DEPARTMENT OF ENERGY**Federal Energy Regulatory Commission****18 CFR Part 40**

[Docket Nos. RM12-6-000 and RM12-7-000]

Revisions to Electric Reliability Organization Definition of Bulk Electric System and Rules of Procedure**AGENCY:** Federal Energy Regulatory Commission, DOE.**ACTION:** Notice of proposed rulemaking.

Two Radial Systems Eligible for Exclusion E1

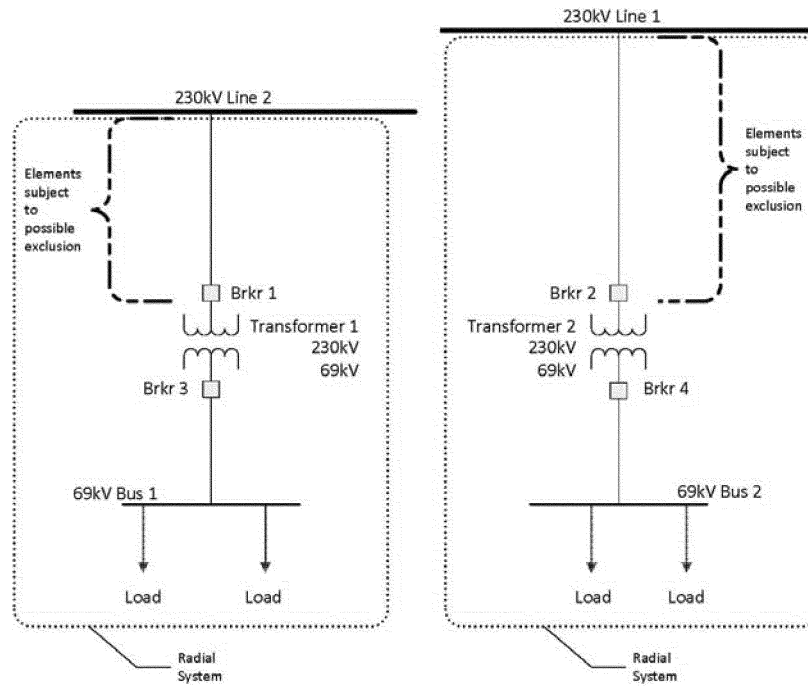
79. Figure 1 below depicts facilities configurations in which all of the 230 kV and 69 kV transmission elements emanate from a single point of connection of 100 kV or higher. The Commission seeks comment on whether each of the radial systems shown in figure 1, the 230 kV elements above each transformer to the point of connection to each 230 kV line, respectively, are excluded from the bulk electric system pursuant to exclusion E1.

Networked Configuration w/115 kV Loop

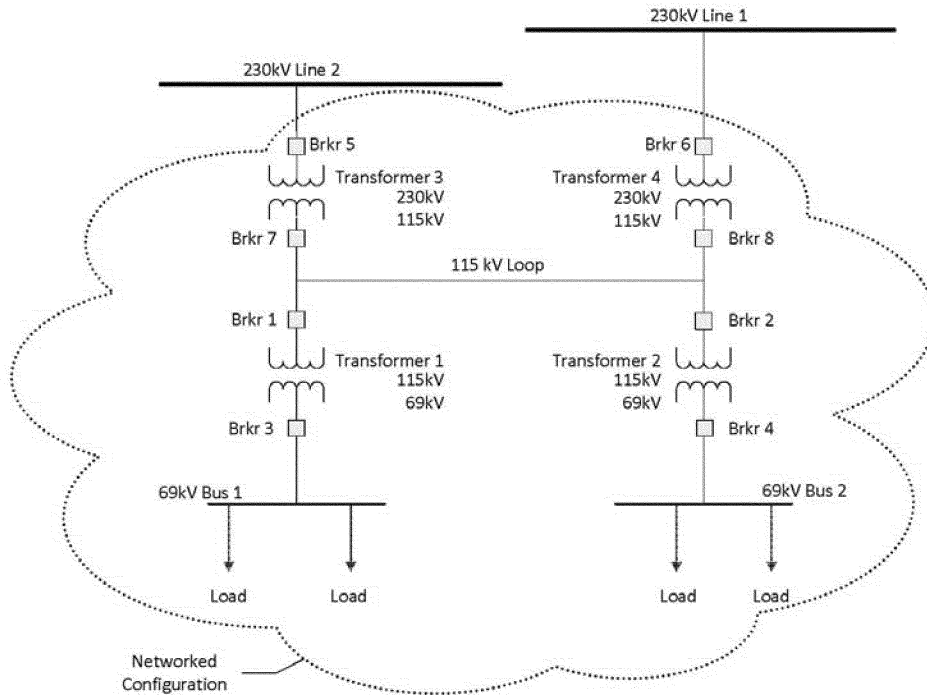
80. Another scenario shown in figure 2 below depicts a configuration containing a 115 kV loop, with the configuration emanating from two points of connection of 100 kV or higher. We seek comment whether, in

shown in figure 2 more appropriately analyzed pursuant to the "local network" exclusion E3 and, if so, what if any elements operated at or above 100 kV would be excluded pursuant to exclusion E3?

Networked Configuration w/69 kV Loop

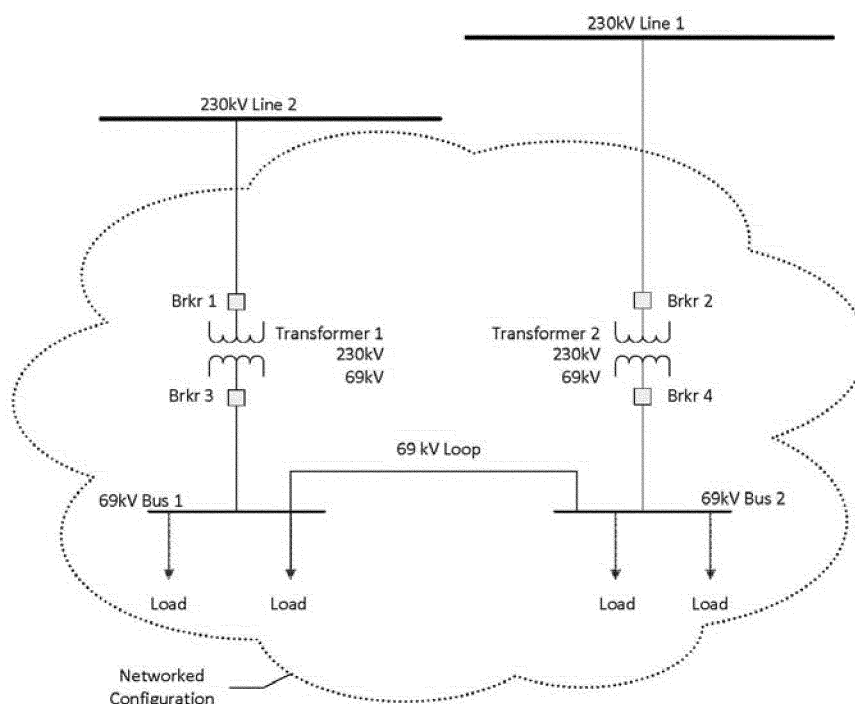
configuration remains contiguous through elements that are operated below 100 kV. For example, figure 3 below depicts a configuration with two points of connection of 100 kV or higher that are contiguous through a 69 kV loop. We seek comment on how to evaluate the configuration in figure 3 vis-à-vis the radial system definition and whether it is appropriate to examine the elements below 100 kV to

determine if the configuration meets the exclusion E1 definition for radial systems. In other words, does figure 3 depict a system emanating from two points of connection at 230 kV and, therefore, the 230 kV elements above the transformers to the points of connection to the two 230 kV lines would not be eligible for the exclusion E1 notwithstanding the connection below 100 kV?

Figure 4
69 kV Networked Configuration with Normally Open Switch

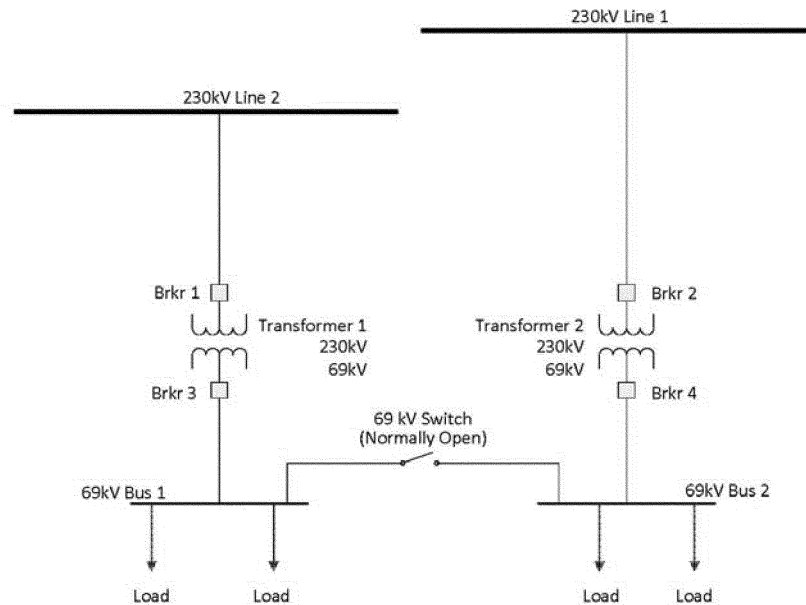
86. Figure 4 below illustrates a configuration with a normally open switch.

NERC states that “[t]he concept that two sets of radial facilities that are normally unconnected to each other should be subject to * * * applicable Reliability Standards during the limited time periods when they are connected by the closing of the normally open switch in the maintenance-related or outage-related circumstances described above would be fundamentally impractical and unworkable (from both the entity’s perspective and the ERO’s perspective), and would misapprehend this very common, reliability-driven facilities configuration.”¹⁰⁴

87. NERC states that “a normally open switch” will be identified in documents such as prints or one-line diagrams and that “[t]he concept and usage of the ‘normally open switch’ in such configuration is well understood in the electric utility industry.”¹⁰⁵ We seek comment on NERC’s characterization and whether the phrase “normally open” is subject to interpretation or misunderstanding, or whether a “normally open” configuration is potentially difficult to oversee. Further, we seek comment on the need of transmission operators or other functional entities to study the system impacts of the closing of a “normally open” switch, or to take other steps to ensure awareness of the impacts of the loop that is created by the closing of the

Networked Configuration w/69 kV Loop

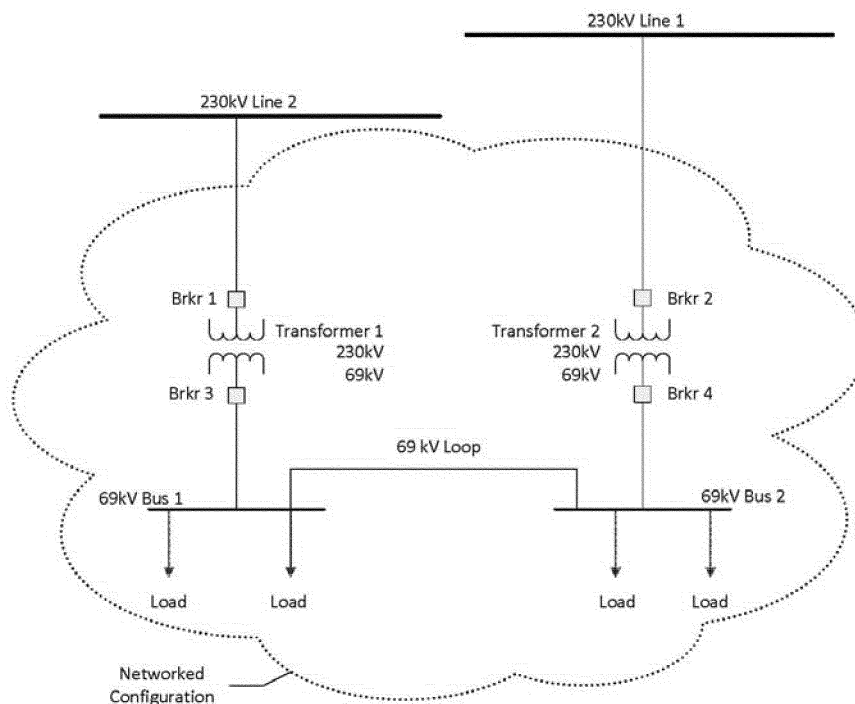
95. As stated above, exclusion E3 defines local networks as “[a] group of contiguous transmission Elements operated at or above 100 kV but less than 300 kV that distribute power to Load rather than transfer bulk-power across the interconnected system.” While the local network exclusion applies to contiguous transmission elements operating at a minimum of 100 kV, it is unclear how the exclusion applies to a looped lower voltage system. For example, figure 5 depicts a 69 kV looped system emanating from two points of connection at 100 kV or higher.

The configuration in figure 5 depicts a group of elements that are contiguous through a 69 kV loop. We seek comment whether the configuration in figure 5
